I. **TITLE:** Request for alternative compliance at 4872 SE Flounder Avenue in Port Salerno, by John L. Hennessee and Melody Thor Fortier, the property owners.

II. **THE APPLICANT REQUESTS ALTERNATIVE COMPLIANCE TO:** Construct a 2,080 sq. ft. metal garage on their 14,244 sq. ft. (0.33 acre) residential lot that does not comply with:

Project name: Detached Garage

Figure 3. Proposed Site Plan

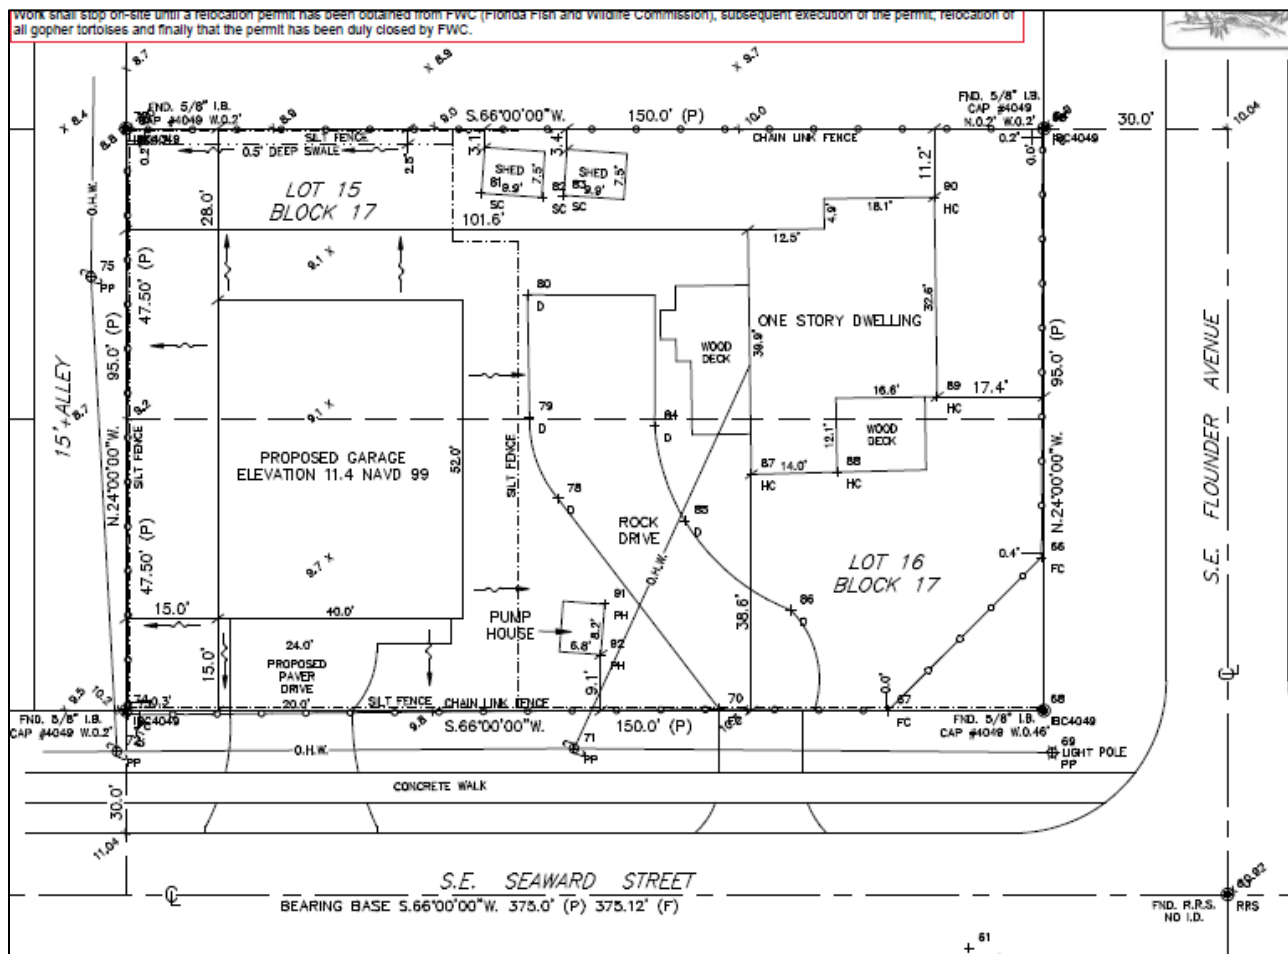
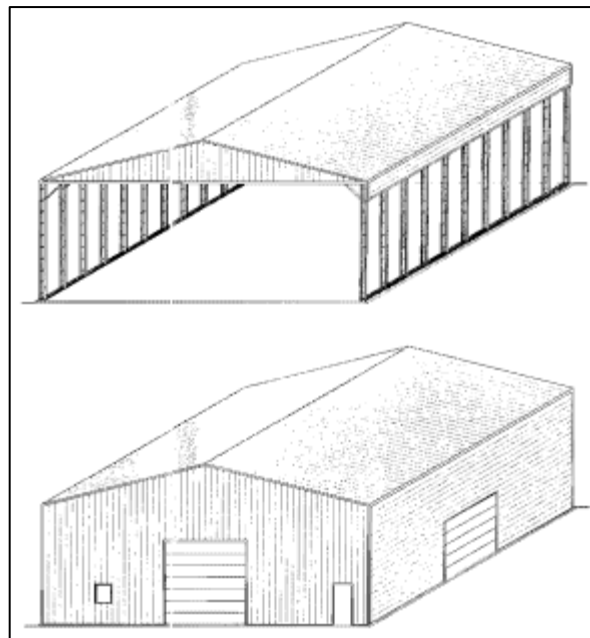
The submission of a landscaping plan to buffer the scale and appearance of the structure is appreciated. Nonetheless, staff believes that the scale and industrial appearance of the proposed building is insufficiently mitigated by the proposed landscaping plan.

1. Construct a smaller garage. To the extent a smaller structure is insufficient to store their cars, boats and recreational vehicles, there are commercial facilities available for the storage of such vehicles.
2. Re-design the site plan to consolidate the driveways and limit the total driveway width to 20 feet.
3. Implement a different building footprint such that the wall facing the Seaward is less than the proposed 40 feet and the building extends further into the lot.
4. Locate the building further away from the southern property line to reduce the visual impact on Seaward Street.
5. Substitute different materials to create a less industrial and more residential appearance.

Figure 4. Proposed Building

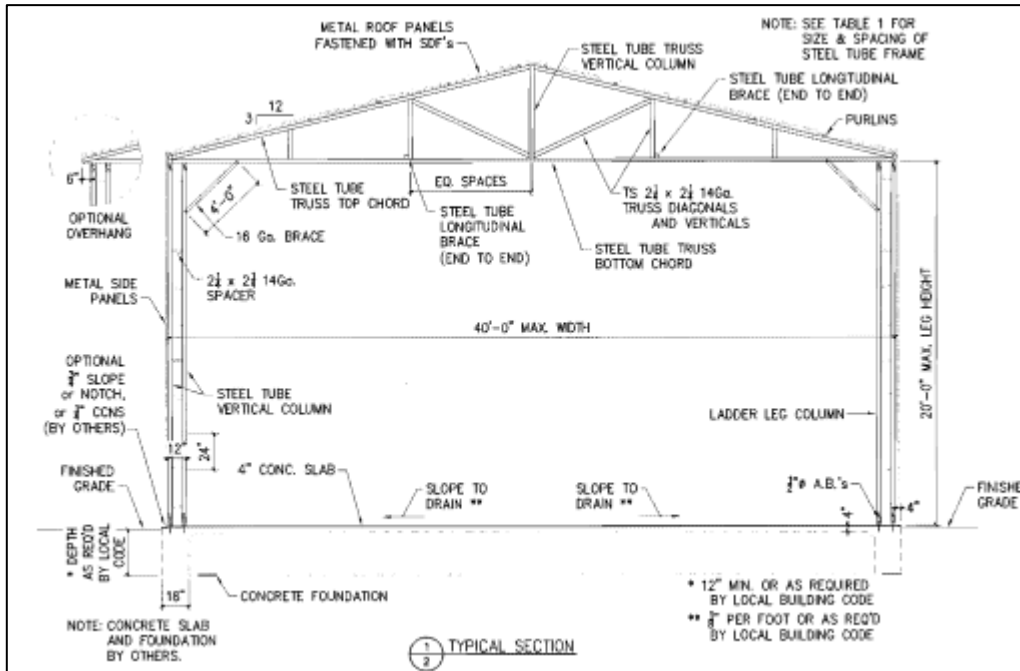
The dwelling on this lot is 1,113 sq. ft. The proposed 2,080 sq. ft. metal garage is nearly twice the size of the dwelling (87% larger).
